## MEMORANDUM

**TO:** District of Columbia Board of Zoning Adjustment

**SUBJECT:** BZA Case No.18285 -- 1045 Wisconsin Ave., NW -- Square 1189 Lots, 830

Figure 2. Site Proposal, with Inset of Elevation from Wisconsin Avenue

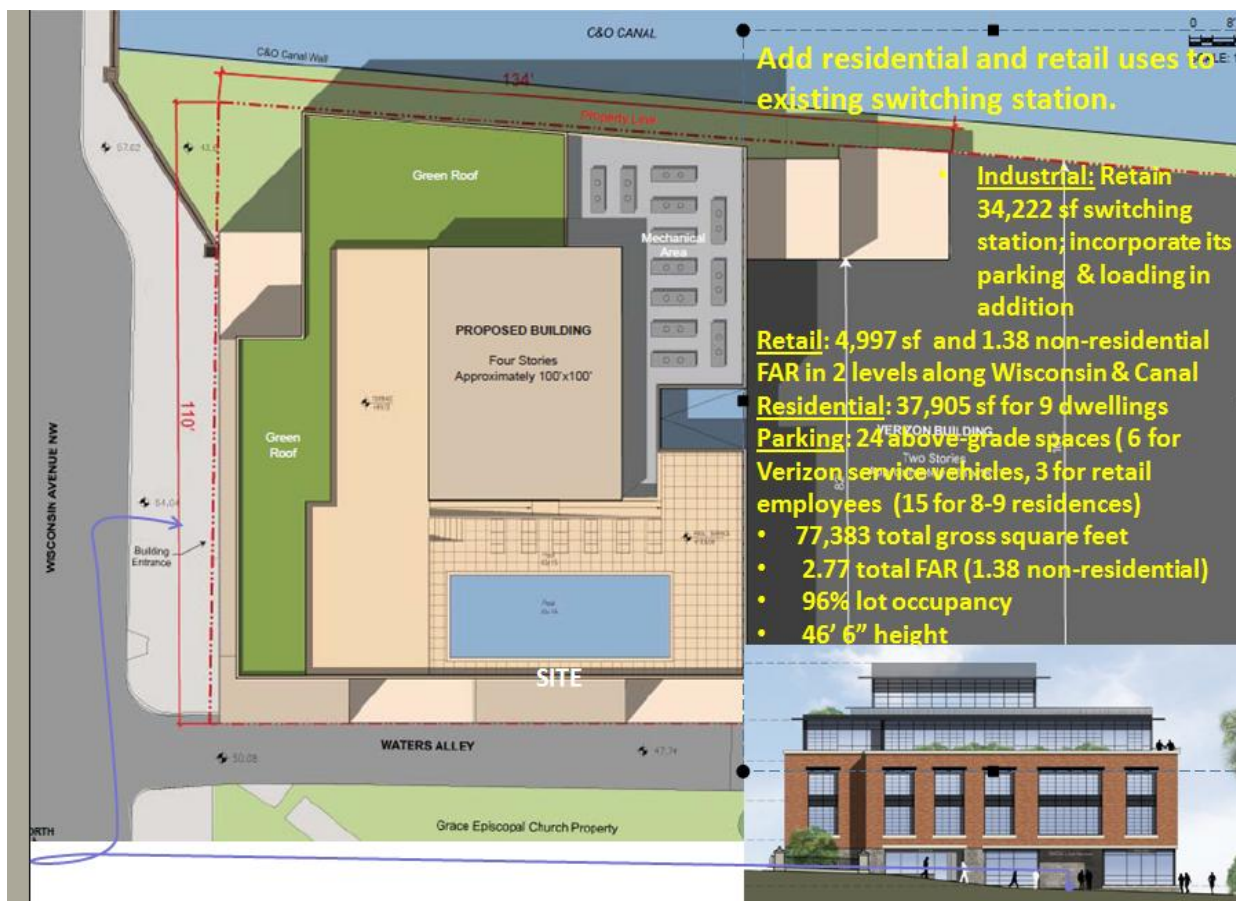
The proposed development is summarized in Figure 2. The applicant seeks relief to enable the construction of an addition an existing Verizon telecommunications switching station. The addition would be located where the company's vehicles now have surface parking. It would contain replacement indoor parking for those vehicles,

residences, retail space and parking for those uses. Pedestrians would enter the addition directly from Wisconsin Avenue. Parking would be entered from Waters Alley, on the site's southern boundary.

OP's report reflects revisions that the applicant filed on November 15, 2011. These increased proposed lot occupancy by an additional 2.3%; recalculated proposed non-residential non-conformity, resulting in a 0.29 FAR reduction; removed a proposed exercise room from the roof; re-located a dumpster so that parking would be no closer than 20 feet from the Wisconsin Avenue property line; and clarified that proposed retail square footage would be less than 5,000 gross square feet and would require no loading.
